ADDENDUM NO. 2

San Antonio Water System

Project Name: **Olmos Basin Central Watershed Sewer Relief Line (C-3), Reaches 1 to 4**

Project No.: **08-2512**

SAWS OLMO'S BASIN CENTRAL WATERSHED
 SEWER RELIEF LINE (C-3) REACHES 1 - 4
 SIPHON PLAN & PROFILE
 STA. 9+62.00 TO STA. 12+12.86

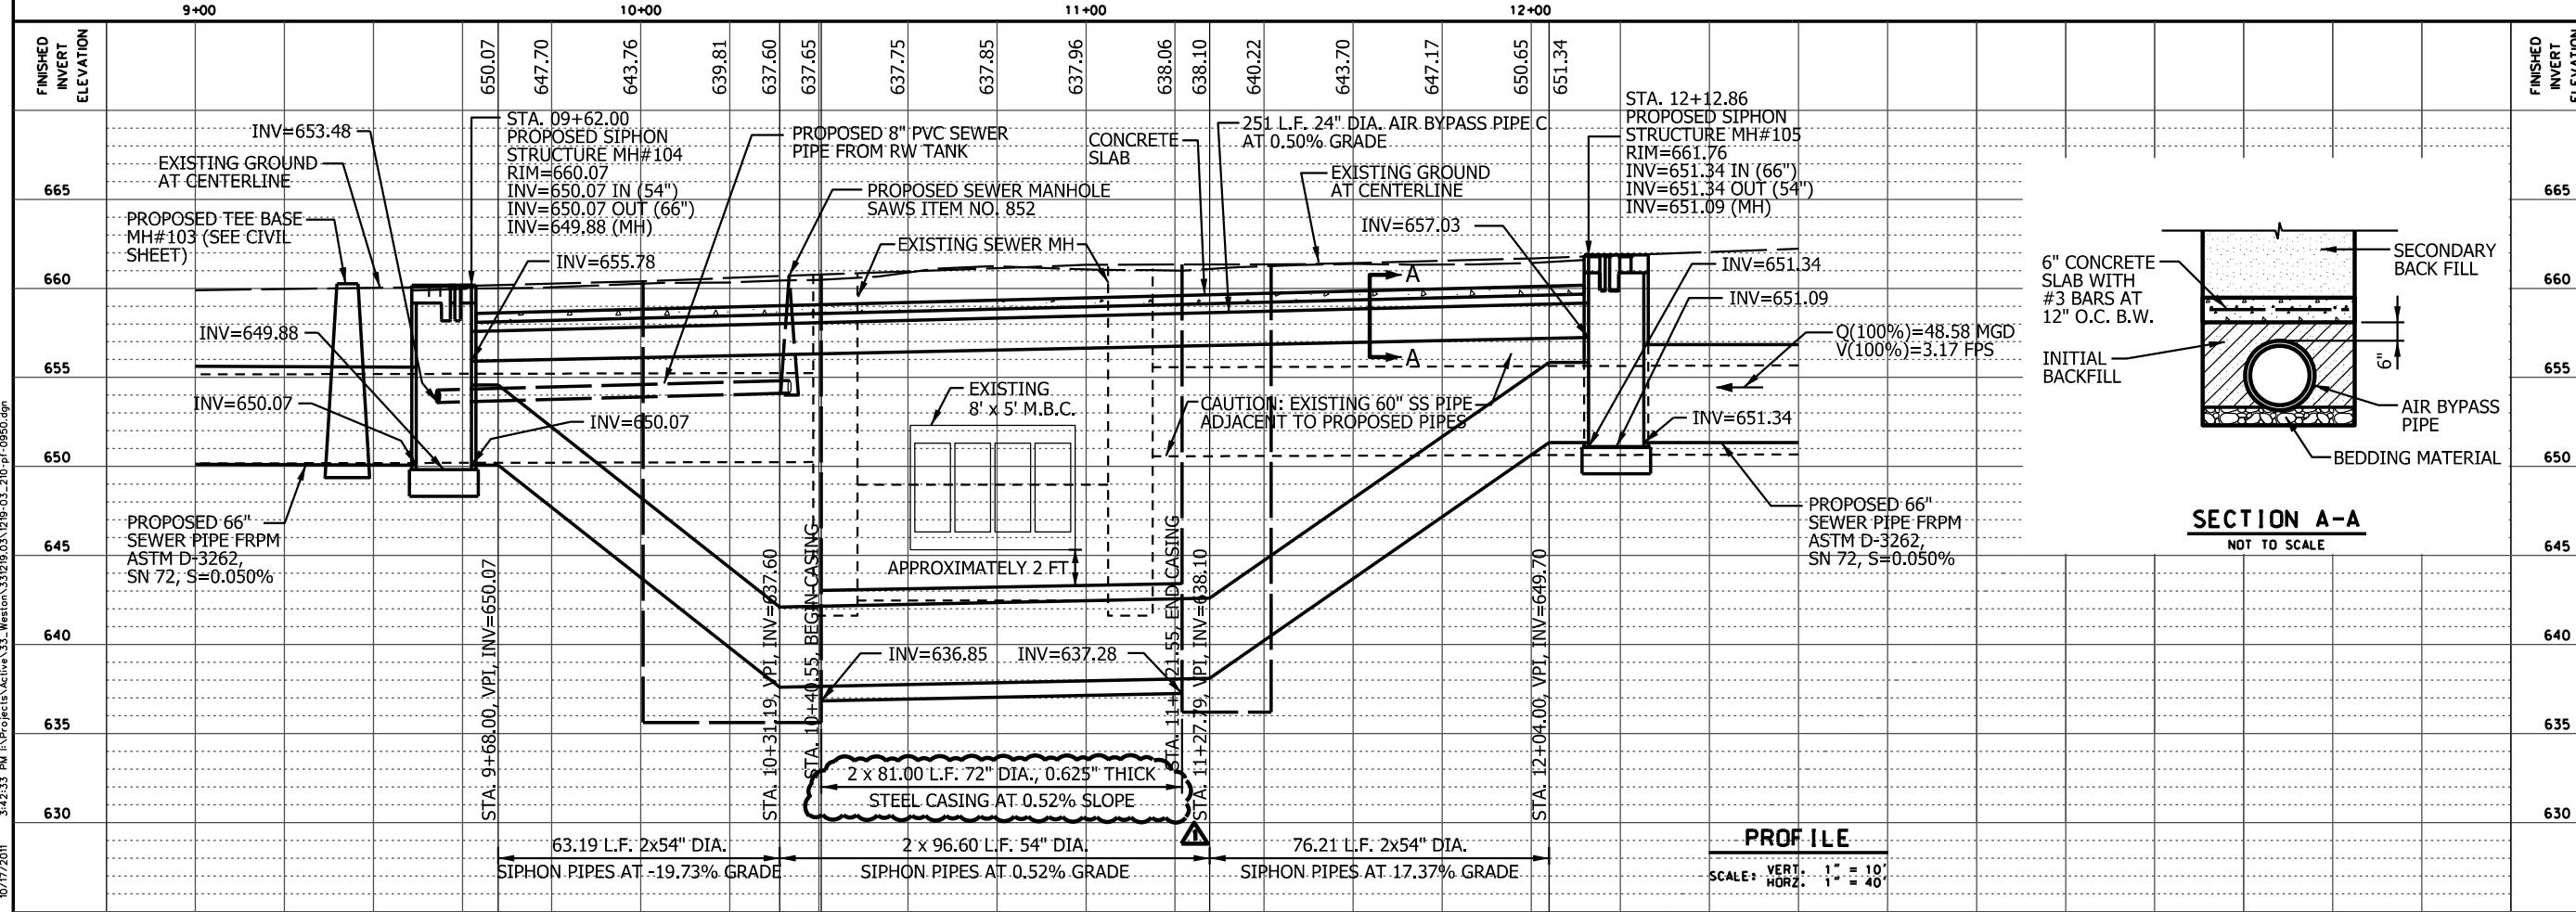
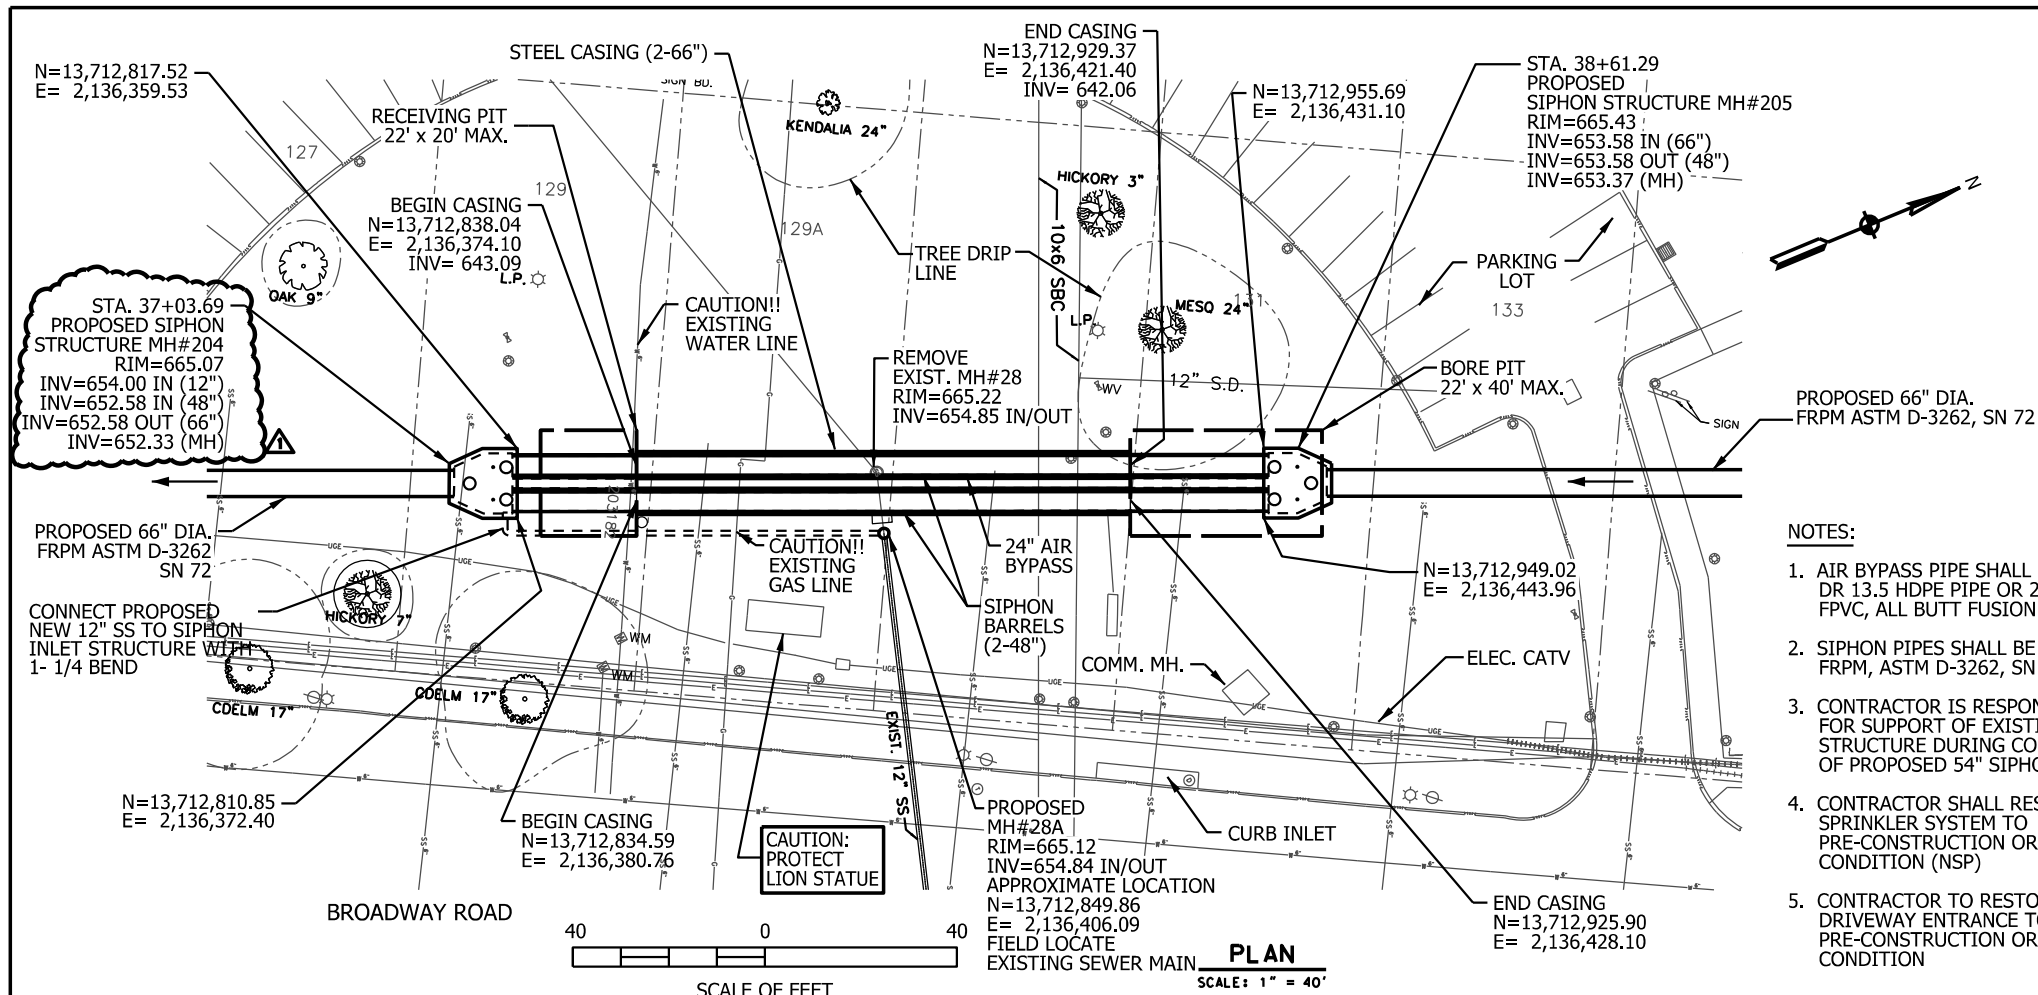
- Item 9: Sheet S-2** – Remove and replace Sheet S-2 with the revised Sheet S-2 attached to this addendum.
Revisions include:
- a) On profile view, delete callout note that reads: “2 x 81.00 L.F.72” DIA., 0.5” THICK STEEL CASING AT 0.52% SLOPE” and replace with “2 x 81.00 L.F.72” DIA., 0.625” THICK STEEL CASING AT 0.52% SLOPE”

SHEET NO. S-3

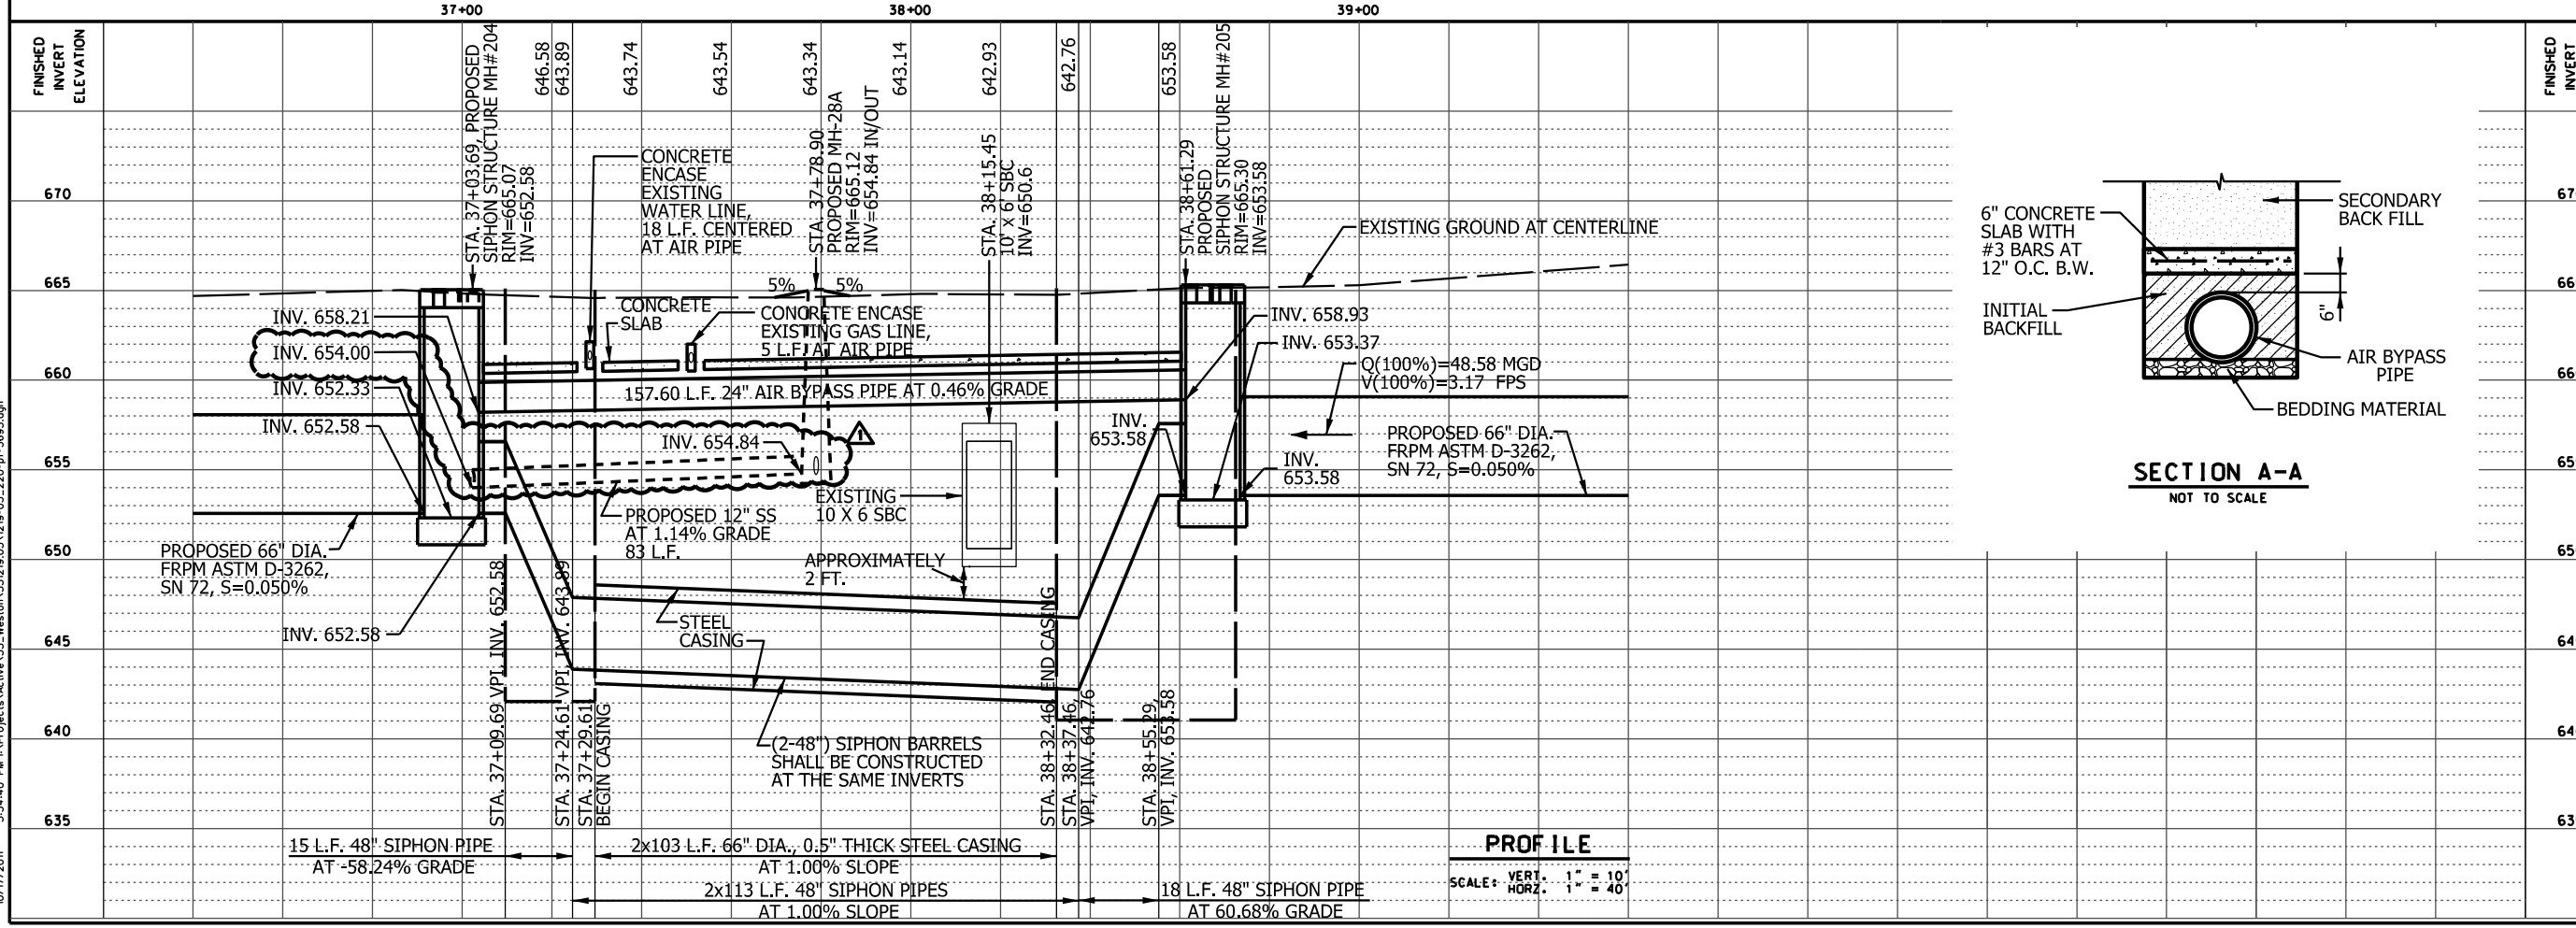
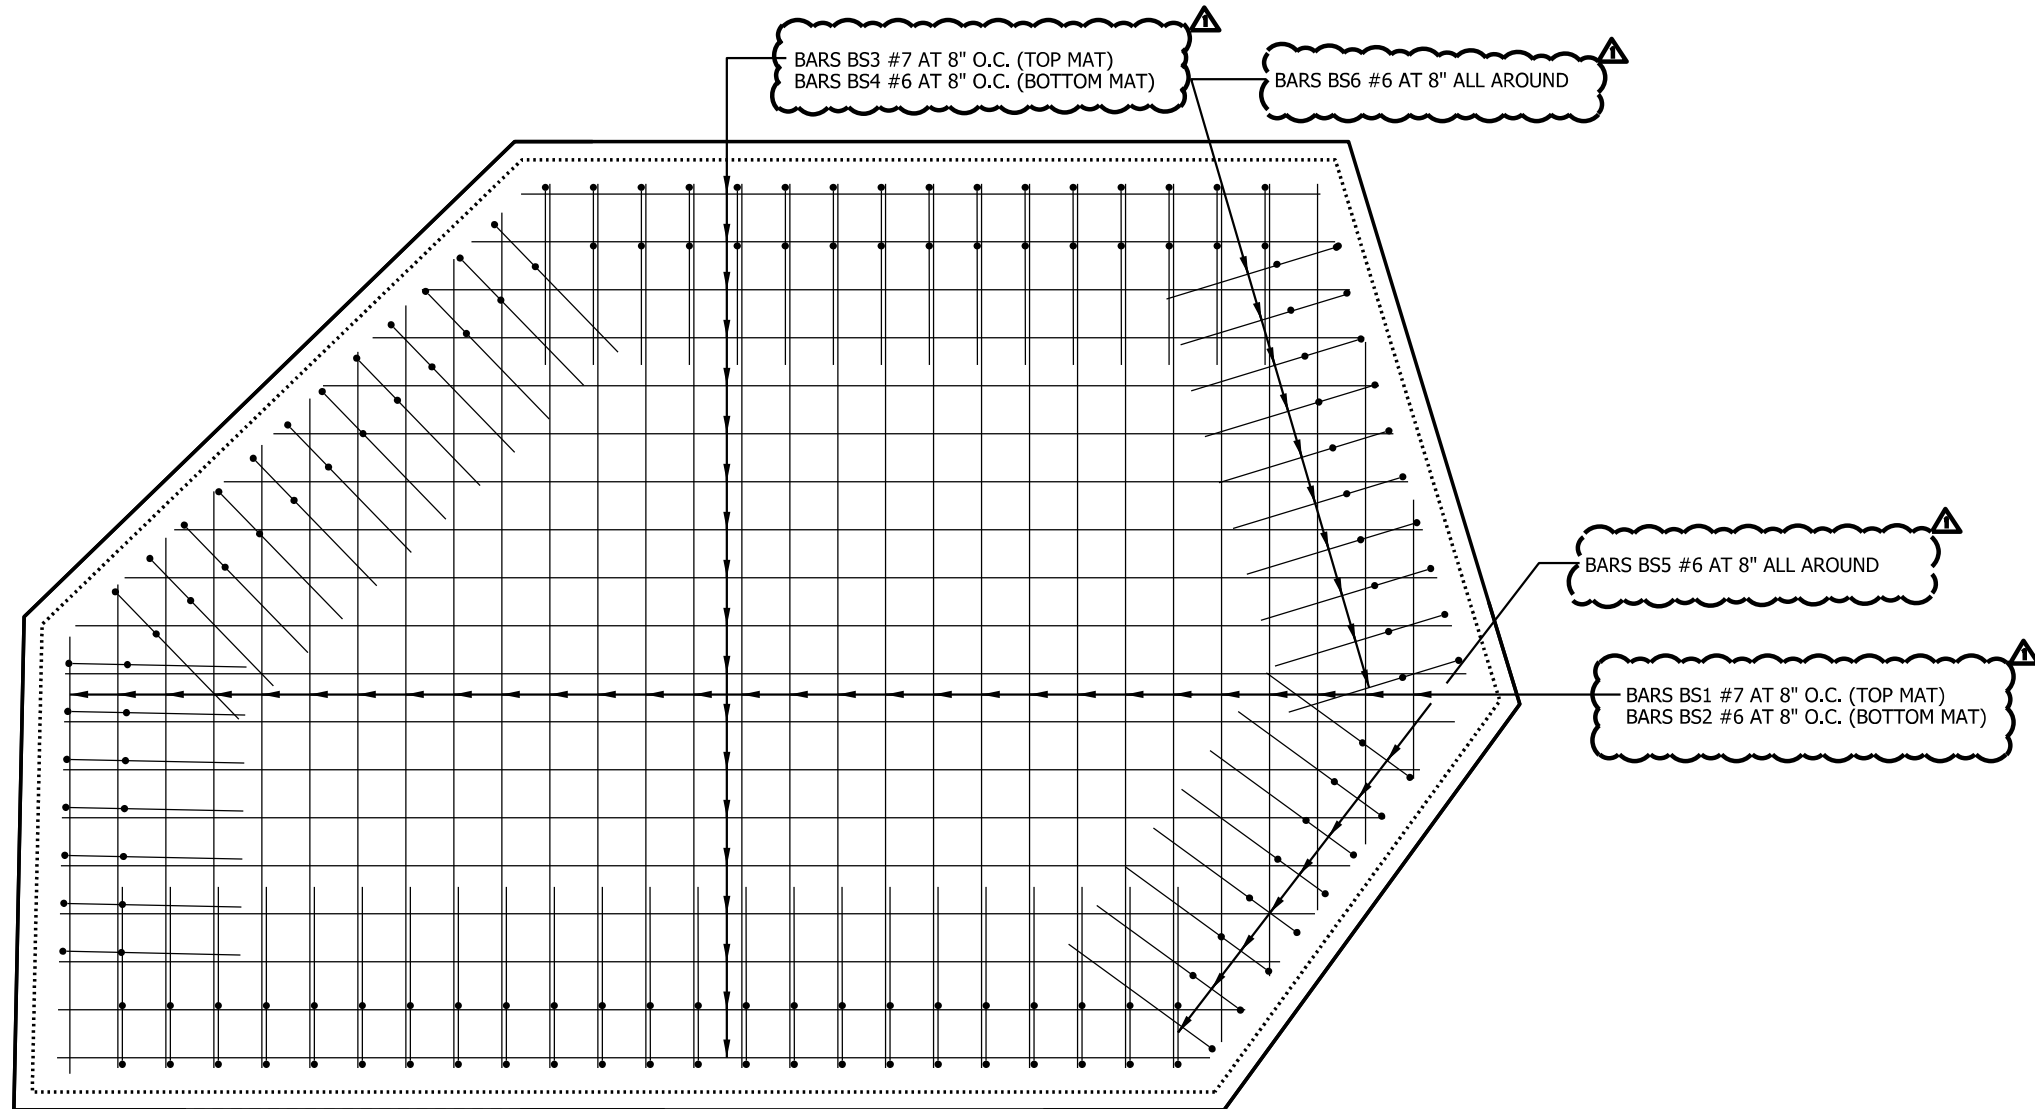
- Item 10: Sheet S-3** – Remove and replace Sheet S-3 with the revised Sheet S-3 attached to this addendum.
Revisions include:
- a) Note that the alignment of the 12" SS main on Sheet S-3 has been revised.

SHEET NO. S-50
 89 OF 123

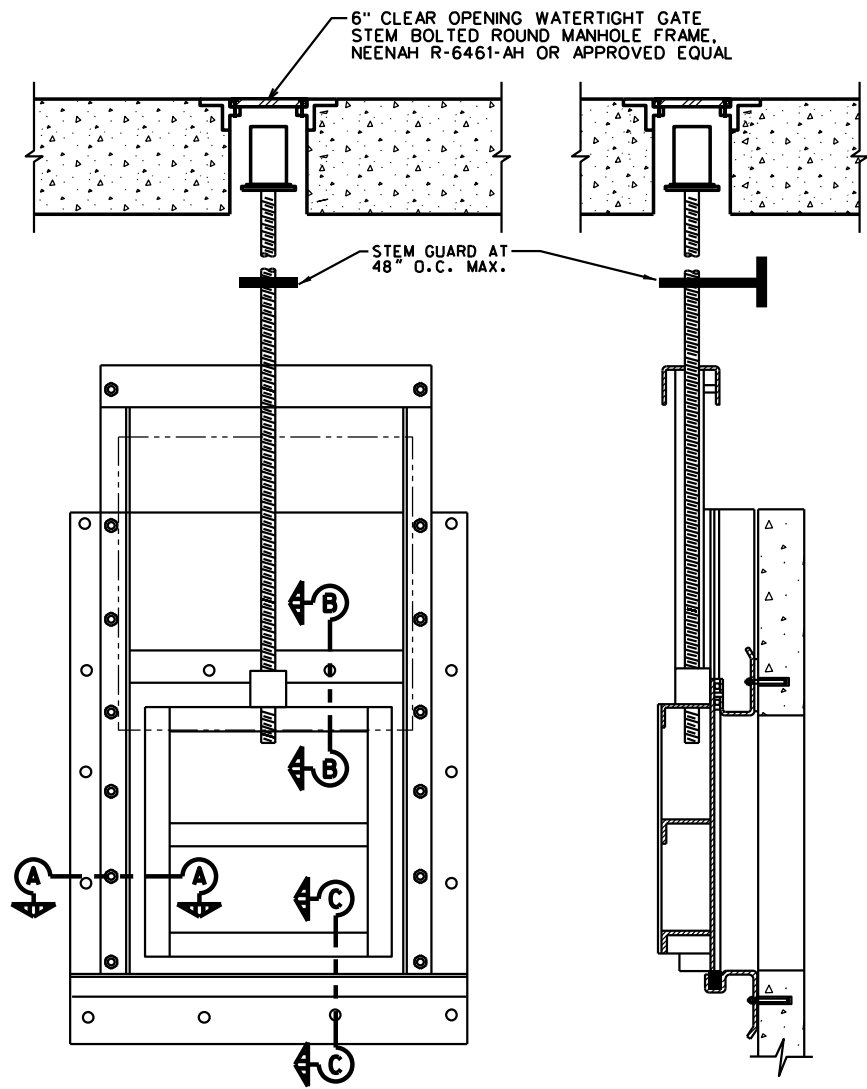
- Item 11: Sheet S-50** – Remove and replace Sheet S-50 with the revised Sheet S-50 attached to this addendum. Revisions include:
- a) Note that the reinforcing bar sizes on sheet S-50 have been added.

NOTES	INITIALS	DATE
DESIGNED BY	KWC	
REVIEWED BY	KMN	
SCALE:	AS SHOWN	
SHEET NO.	S-55	
	94 OF 123

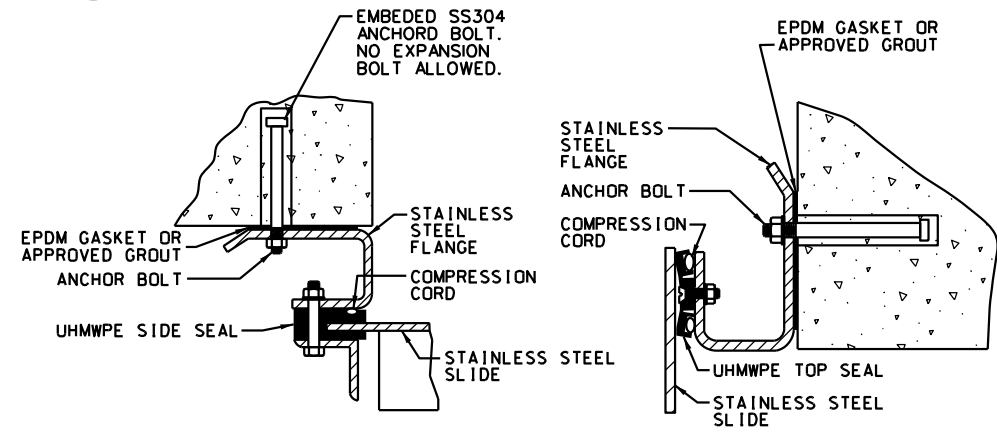
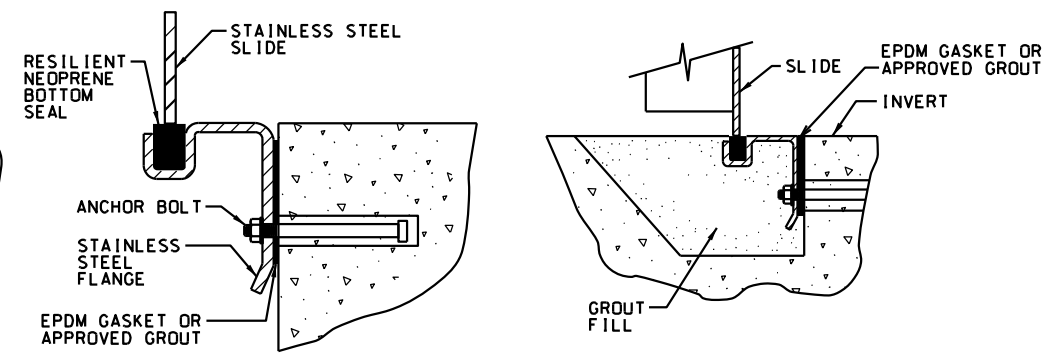
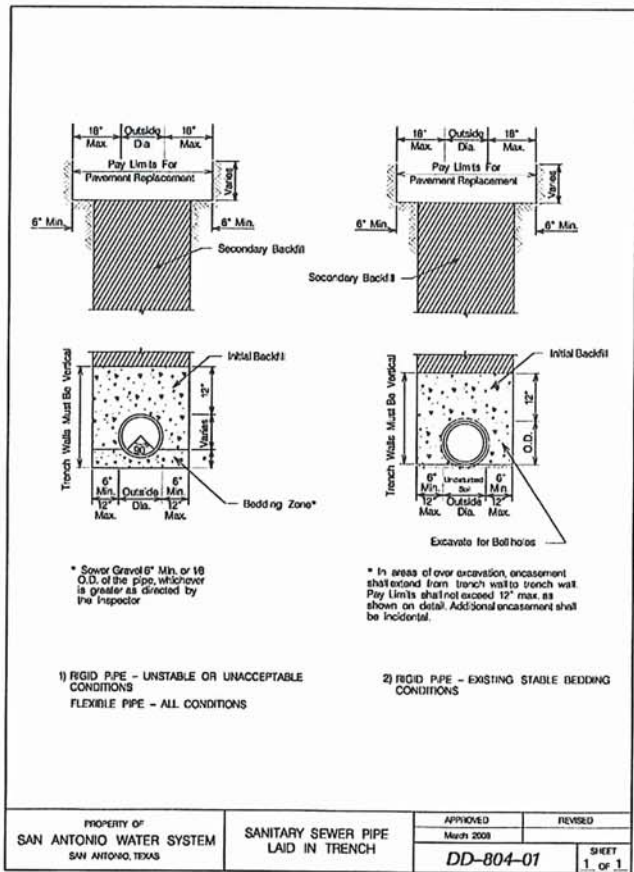
- Item 12: Sheet S-55** – Remove and replace Sheet S-55 with the revised Sheet S-55 attached to this addendum. Revisions include:
- a) Note that a Sliding Gate and Stop Log Schedule has been added.
